CP-200900668
Log # TXNB-09011

**SUBJECT: COMANCHE PEAK NUCLEAR POWER PLANT, UNITS 3 AND 4
DOCKET NUMBERS 52-034 AND 52-035
COMBINED LICENSE APPLICATION UPDATE TRACKING REPORT**

**Comanche Peak Nuclear Power Plant, Units 3 & 4
COL Application**

Figure 4.1-1 Detailed Site Plot plan with Construction Laydown Areas

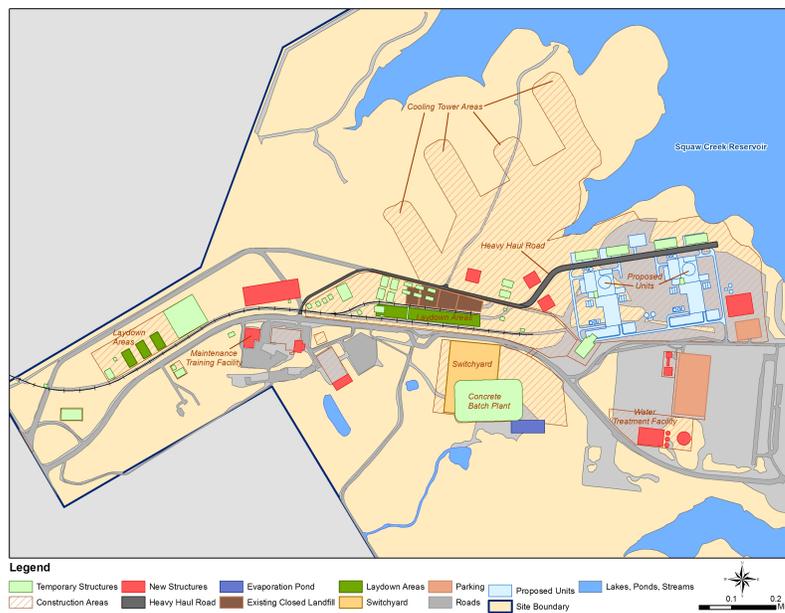
SOC-03	Figure 4.4-1		Increase information as discussed with the NRC	Added table to show total project staffing.	2
GEN-05 GEN-06 SOC-16 CR-03	List of Tables	4-v	Increase information as discussed with the NRC.	Added Table 4.9-1.	3
LU-10	Figure 4.1-1	--	Increase information as discussed with the NRC.	Revised figure to show batch plant contained within the property boundary.	3
